2.C.2.1
FYR 85-62

May 30, 1985

Subject: Supplemental Information for Proposed Change No. 184 - Safety
Valve Setpoint Tolerance

Figure 1
Loss of Load Transient
Turbine Trip From Full Power

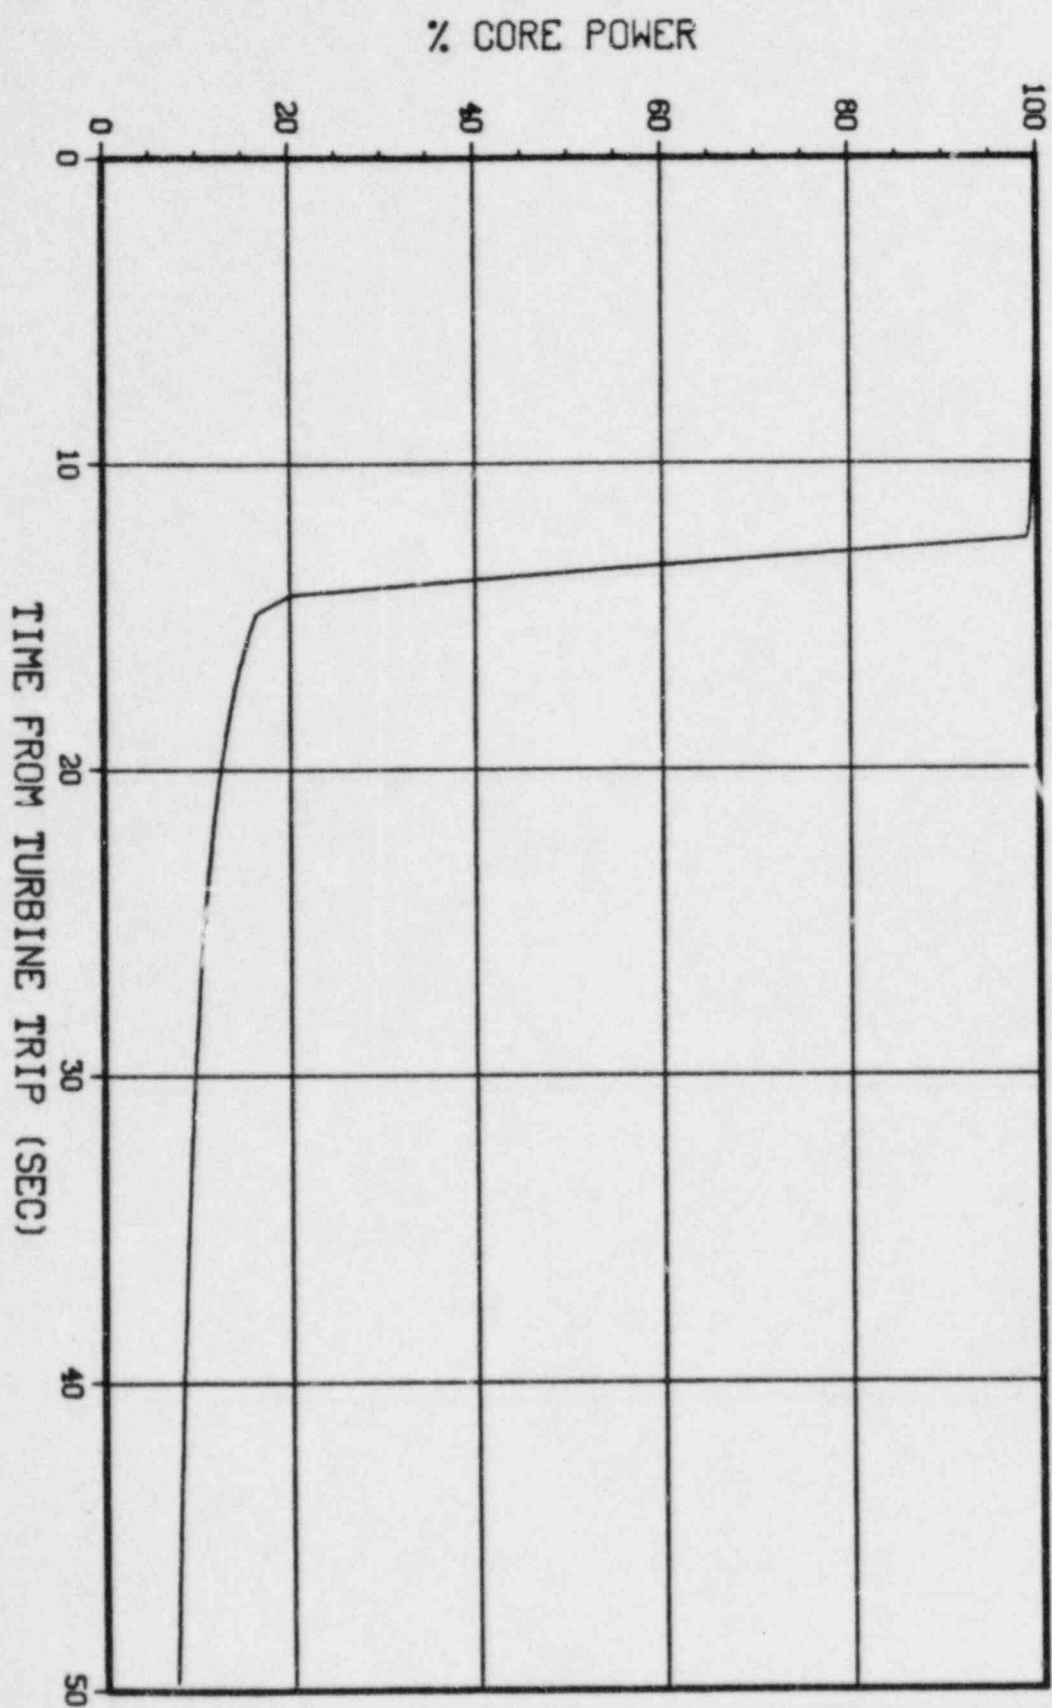
Reference (b) transmitted additional information to supplement our proposed Technical Specification change of Reference (c) to revise the setpoint tolerance for the pressurizer code safety valves. This letter provides revised Figures 1-4 previously submitted in Reference (b). These revised figures show the effect of crediting the high Main Coolant System pressure trip.
